Intel[®] Celeron[®] Processor

Specification Update

August 2008

Revision 053

Figure 1 Celeron® on 0.13 Micron Processor 256K Platforms Workaround

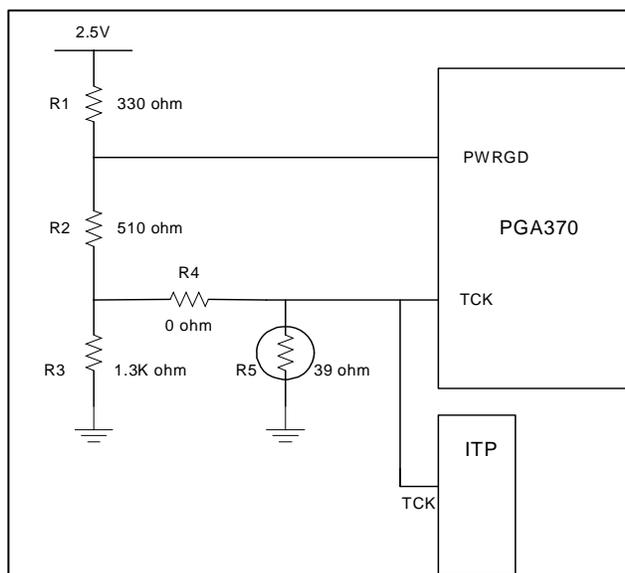
Workaround: To prevent the risk of power-on boot failures or catastrophic thermal failures, a platform workaround is required. The system must provide a rising edge on the TCK signal during the power-on sequence that meets all of the following requirements:

Please note, the example workaround circuits attached require circuit modification for ITP tools to function correctly. These modifications must remove the workaround circuitry from the platform and may cause systems to fail to boot. Review the accompanying notes with each workaround for ITP modification details. If the system fails to boot when using ITP, issuing the ITP 'Reset Target' command on failing systems will reset the system and provide a sufficient rising edge on the TCK pin to ensure proper system boot.

In addition, the example workaround circuits shown do not support production motherboard test methodologies that require the use of the processor JTAG/TAP port. Alternative workaround solutions must be found if such test capability is required.
